# Review: Proportional Integral controller Enhanced (PIE) Active Queue Management (AQM) [PNB<sup>+</sup>15]

Bob Briscoe\*

09 May 2015

Figure 1: Comparison of Proposed Autotuning Function with Look-Up Table Approach

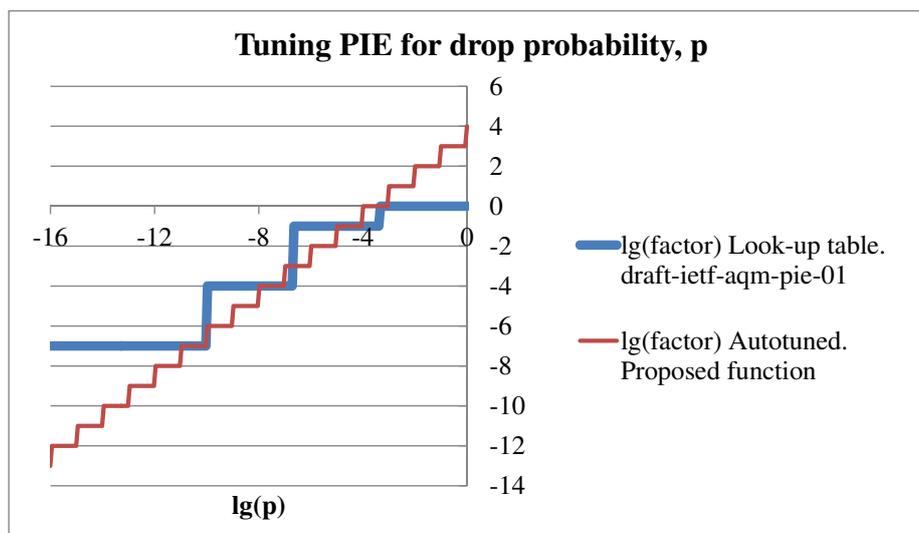
I am concerned that using a look-up table is not 'autotuning'. It does not tune beyond the bounds of the table. I.e. everything below 0.1% (the lowest value) will have to make do with division by 128 (see Fig 1). To properly cover the operational range of values of  $p$  would require far too many "else ifs" in sequence.

Anyway, that look-up table is surely unnecessary. Below I’ve repeated the look-up table of  $p$  against ‘factor’ from the draft and added more columns to show that the factors in the look-up table approximate to a linear relationship with  $p$  (compare  $p_{\text{mid}}$  and  $\text{factor}/16$ ). This is not surprising because the draft says that the factors were chosen so that the changes in  $p$  were proportionate to the size of  $p$  before the change.

So, why not just set

$$\text{factor} = p * \text{ALPHA\_DEFAULT}$$

with ALPHA\_DEFAULT = 16? It’s a decent approximation of the look-up table of factors in the draft, particularly given the draft says that the exact values of the factors are not critically sensitive. Importantly, it continues indefinitely as  $p$  gets smaller, whereas the look-up table approach always stops somewhere (see Fig 1).

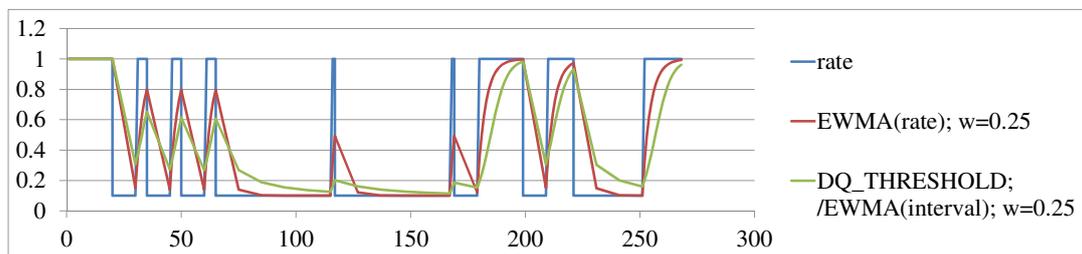
The queue is only sampled and  $p$  is only updated once every `T_UPDATE` (= 16ms by default). This might be appropriate for properly ACK-clocked or paced long-running flows. However, more bursty traffic is often the norm, with lots of short flows arriving at irregular intervals. In such bursty scenarios, the queue will tend to vary rapidly, so numerous samples will be needed to characterise the average queue. By spacing samples so widely apart, it seems likely to take a very long time for  $p$  to reach an appropriate value, by which time it will probably no longer be appropriate.

PIE's sampling rate might be appropriate to minimise processing on cost-reduced equipment like a residential gateway for a link rate of say 8Mb/s (it then equates to about one in ten 1500 B packets). But, even then, it seems unnecessarily infrequent. The draft should explain the tradeoffs that were made before settling on this sampling rate, and whether evaluations have shown that a shorter sampling time (if feasible) would be beneficial?

The draft says “Given modern high speed links, this period translates into once every tens, hundreds or even thousands of packets.” However, it seems that the benefit of reducing background processing beyond tens of packets becomes insignificant compared to the sloppiness of such infrequent updates to  $p$ .

Figure 2: Exponentially Weighted Moving Average vs. PIE's Non-EWMA Approach for an Example Sequence of Rate Variations

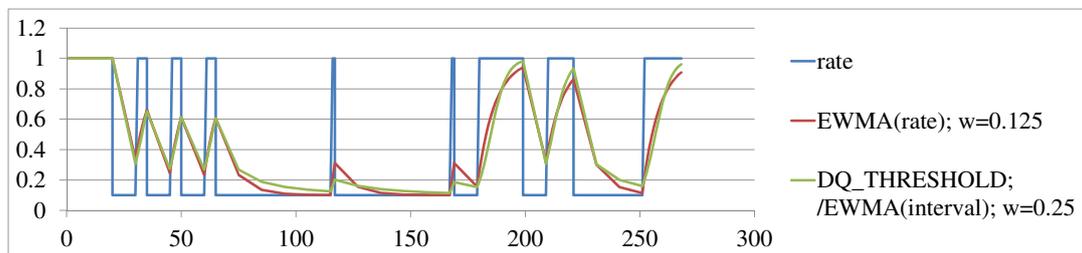
However, taking an exponentially weighted moving average (EWMA) of the dequeue times in the denominator is not the same as taking the EWMA of the rates. The pseudocode continually measures the sequence of dequeue times,  $t_1, t_2, t_3, \dots$  that it takes to transmit constant amounts of bytes (DQ\_THRESHOLD). Then the exponentially weighted moving average (EWMA) of the rate should be:

Fig 2 compares a correctly calculated EWMA with the non-EWMA in the PIE draft. They are both shown averaging the departure rate of a link that varies between 1 unit and 0.1 units for the same sequence of example durations. For the record, the formula for the correct EWMA is:

The top chart (2a) shows that the PIE approach is considerably slower to converge than the correct EWMA with the same weight (1/4 in both cases). In the bottom chart (2b), the weight of the correct EWMA has been scaled down to 1/8 in an attempt to match the outcome of the PIE approach. Looking closely it can be seen that the PIE approach is faster than exponential at first, then slower than exponential later. This explains why, whatever constant scaling is chosen, even if one part of the trace can be made to match, other parts will fail to match.

It would be hard to implement a correct EWMA unless constant time periods were used instead of constant amounts of bytes. It might still be acceptable to use the PIE formula as an approximation. However, it should be considered whether there might be pathological scenarios where the error would be unacceptable.

Figure 3: Rerandomization of Derandomized Drop Spacing

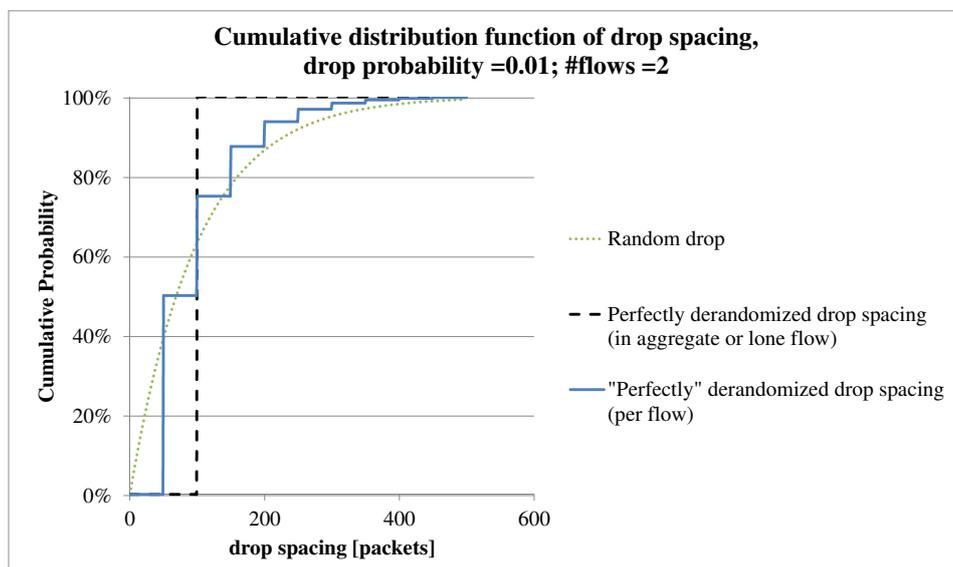
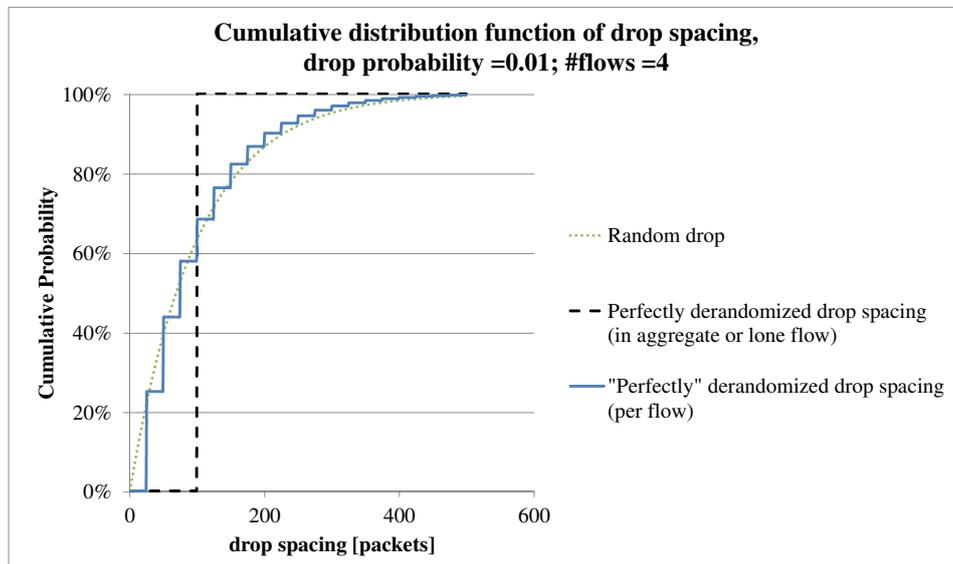
Unless there is only one flow in the queue (e.g. per-flow queuing), derandomizing the spacing between drops just wastes cycles. So, if PIE is in a shared FIFO queue, the derandomization routine might as well be called `heat_the_room()`.

In fact, for any number of flows greater than one, if the cumulative distribution function of spacings with derandomization is laid on top of the CDF without, they follow nearly the same curve, except the derandomized one is stepped (see Fig 3). Derandomization does avoid bunching of drops, but it does not prevent some drops arriving very far apart, as the figure shows. This is true no matter how few flows there are, unless there is just one (see the lower figure for 2 flows).

- Is it worth including the derandomization code if multiple flows share the queue? No.
- Is it worth including the derandomization code with per-flow queuing? I'm not convinced.
